Improved extinction ratio specifications

Piers Dawe

Mellanox

50GBASE-FR transmitter setup map

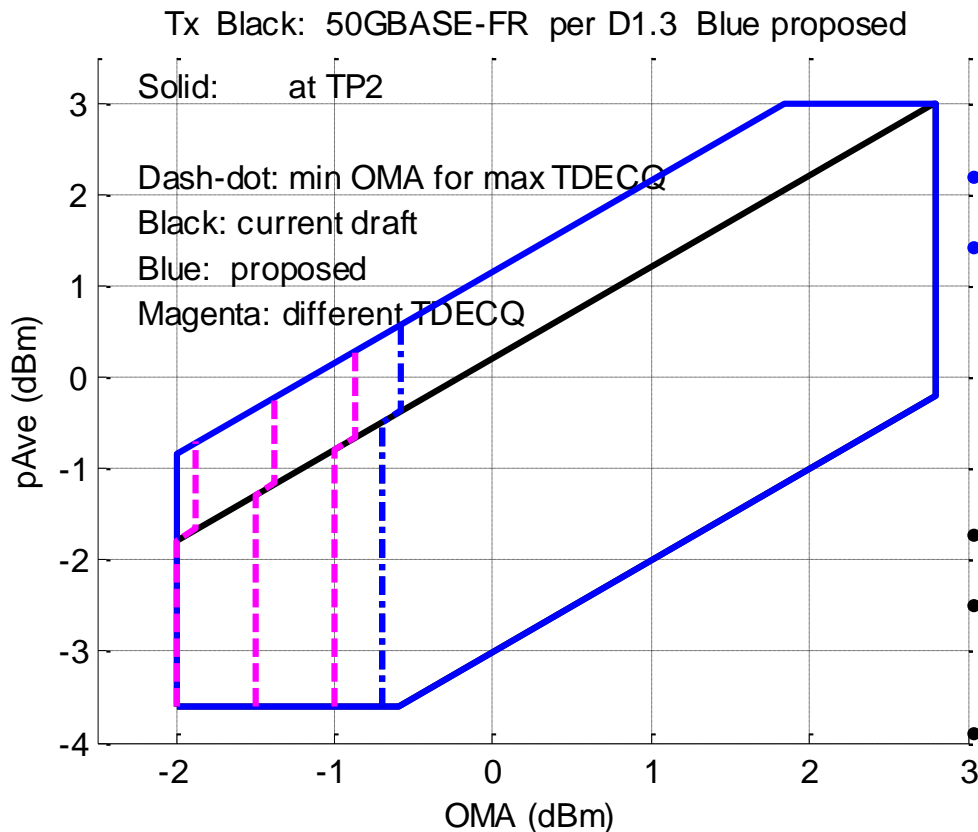
- Black polygon: Tx spec in D1.3, with 4.5 dB min. extinction ratio

- 50GBASE-FR, 200GBASE-FR4 and 400GBASE-FR8 have the same extinction ratio, transmitter, receiver and cable plant reflectances, and channel insertion loss

- So the MPI characteristics are very similar

50GBASE-FR transmitter setup map: proposal

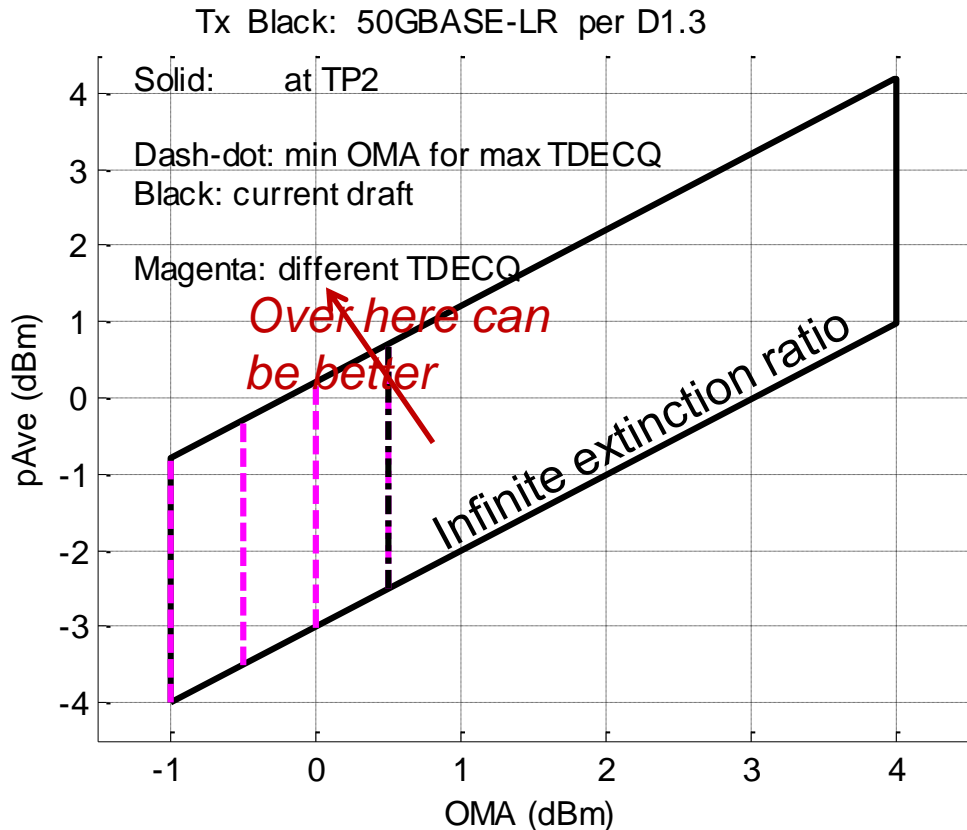
- Black polygon (partly hidden under blue one): Tx spec in D1.3, with 4.5 dB min. extinction ratio
- Blue polygon: proposal: 3.5 dB
- And 0.1 dB more OMA-TDECQ below 4.5 dB
 - For extra multipath interference penalty
 - [anslow 01 0517 smf](#) slides 7-10

• Tx spec becomes easier

• Channel, connectors and receivers don't change

50GBASE-LR transmitter setup map

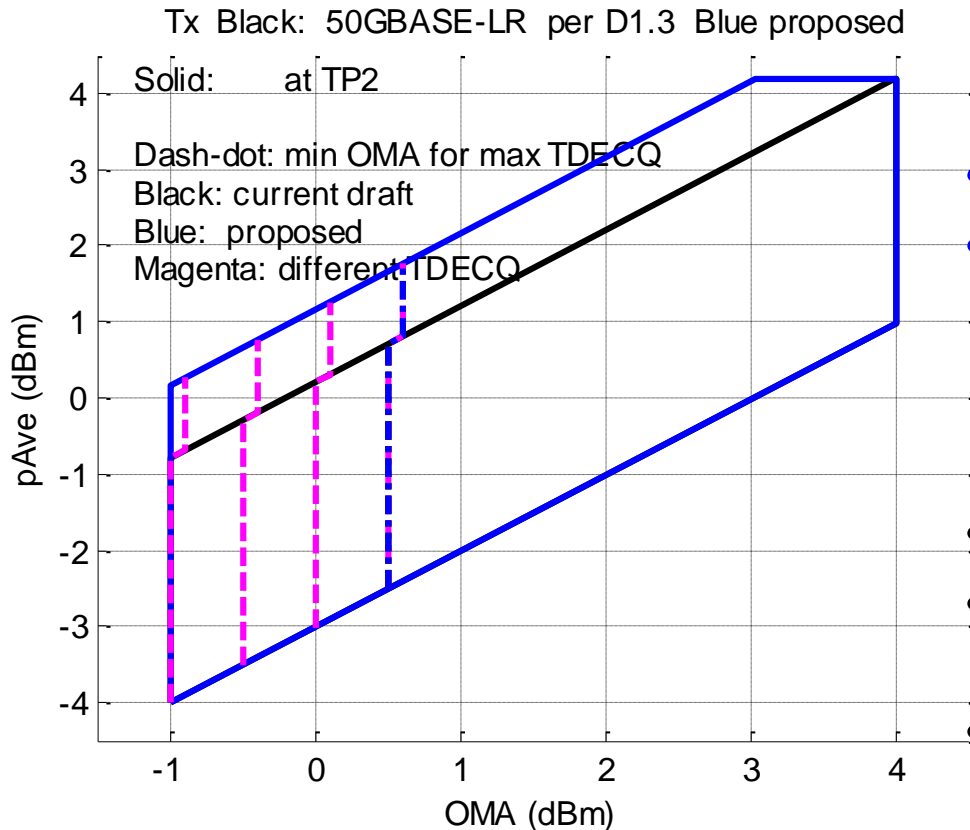
- Black polygon: Tx spec in D1.3, with 4.5 dB min. extinction ratio
- 50GBASE-LR, 200GBASE-LR4 and 400GBASE-LR8 have the same extinction ratio, transmitter, receiver and cable plant reflectances, and channel insertion loss
- So the MPI characteristics are very similar

50GBASE-LR transmitter setup map: proposal

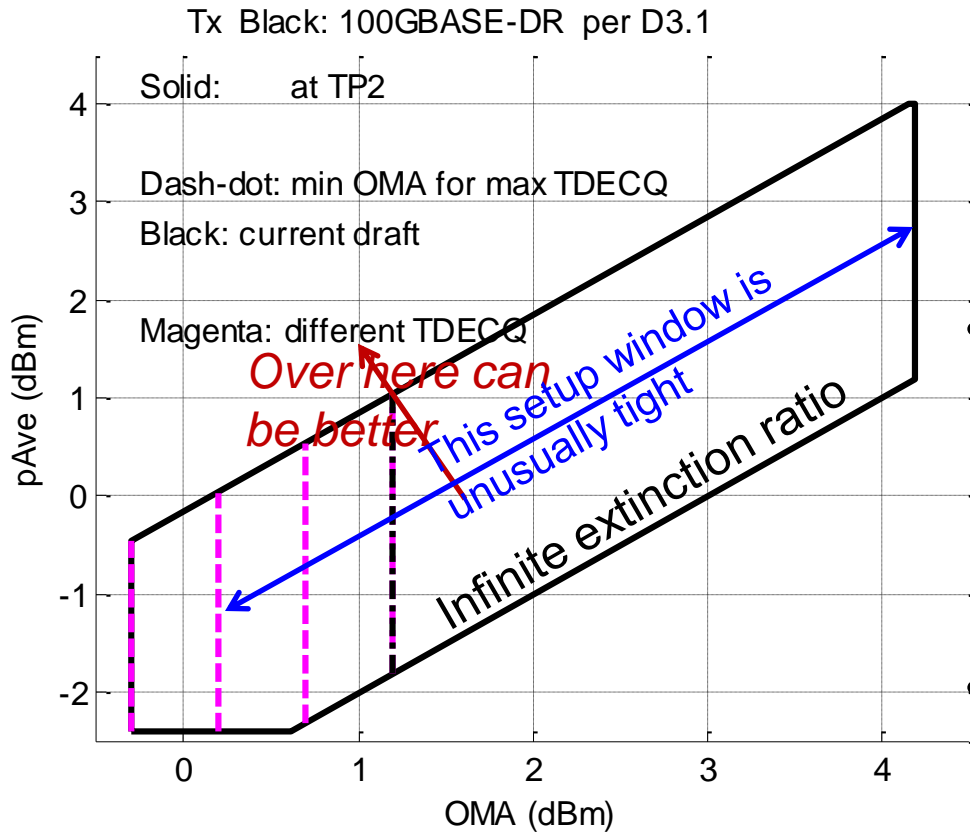
- Black polygon (partly hidden under blue one): Tx spec in D1.3, with 4.5 dB min. extinction ratio
- Blue polygon: proposal: 3.5 dB
- And 0.1 dB more OMA-TDECQ below 4.5 dB
 - For extra multipath interference penalty
 - [anslow 01 0517 smf](#) slides 3-6
- Tx spec becomes easier
- Channel, connectors and receivers don't change
- **Other options include:**
 - Improve Rx sensitivity, and stressed sensitivity, and increase budget, by 0.1 dB (for any extinction ratio)
 - Tighten Tx minimum OMA-TDECQ, OMA and minimum average power, and increase budget, by 0.1 dB for any extinction ratio
 - Include MPI in TDECQ

100GBASE-DR transmitter setup map

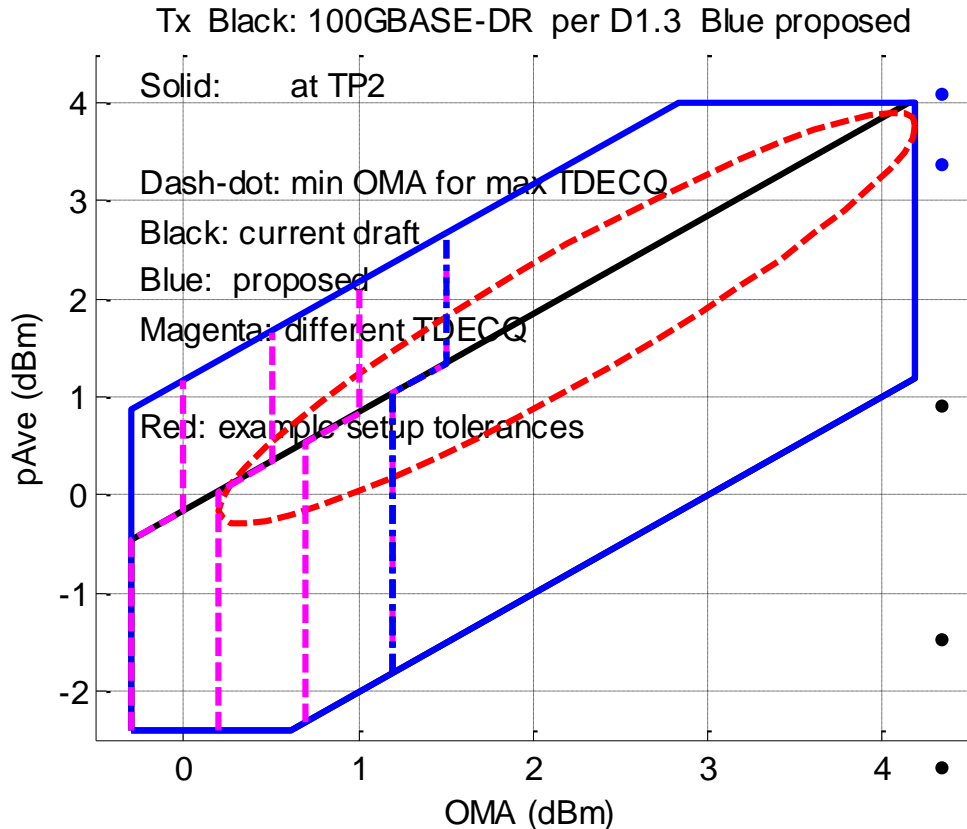
- Black polygon: Tx spec in D1.3, with 5 dB min. extinction ratio

- 100GBASE-DR has the same extinction ratio, and transmitter and receiver reflectances, as 400GBASE-DR4, but different channel insertion loss and reflectances

- So the MPI characteristics are different

100GBASE-DR transmitter setup map: proposal A

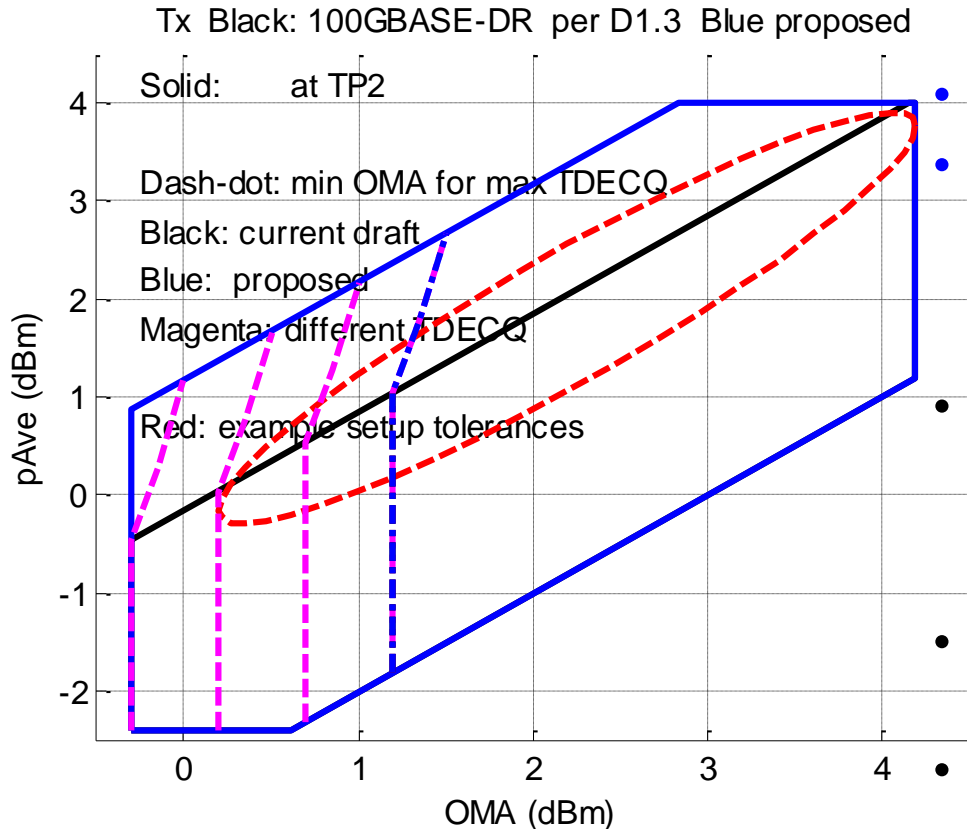
- Black polygon (partly hidden under blue one): Tx spec in D1.3, with 4.5 dB min. extinction ratio

- Blue polygon: proposal: 3.5 dB
- And 0.3 dB more OMA-TDECQ below 4.5 dB

- For extra multipath interference penalty
- [anslow 01_0517 smf](#) slides 3-6

- Tx spec becomes easier **apart from tolerancing**

- Needs very good power control (output coupling, tracking, ageing)
